## **CASHLESS TOLLING**

**TA 19-1, Contract No. D800002**

**Addendum #2**

**March 22, 2019**

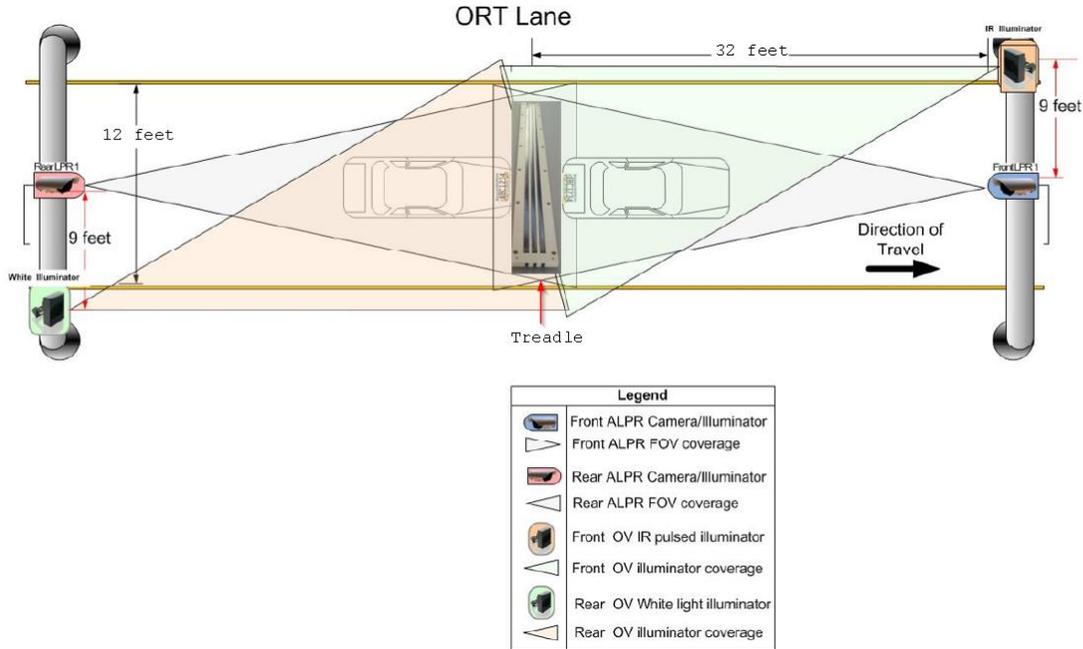
The Design-Builder shall provide and install ~~three~~two appropriately sized conduits for power cables, communication cables, and possible future addition of a second front camera in each instrumented lane. Power cables and communication cables shall be routed through separate conduits. The Design Builder shall provide a hinged, stainless steel junction box for D.C. power and communications within 6 feet of each camera to support the “whip” cables from the camera/illuminator to the junction box. The enclosure is to be NEMA 4x rated and have a minimum size of 12”H x 12”W x 6”D. The enclosure must include a removable back panel and no conduit connectors shall impede the installation and removal of the back panel. The design builder shall install 4 weather tight connectors for ¼” diameter cables in the enclosure to support the whip cables. No penetrations are permitted through the top of the enclosure.
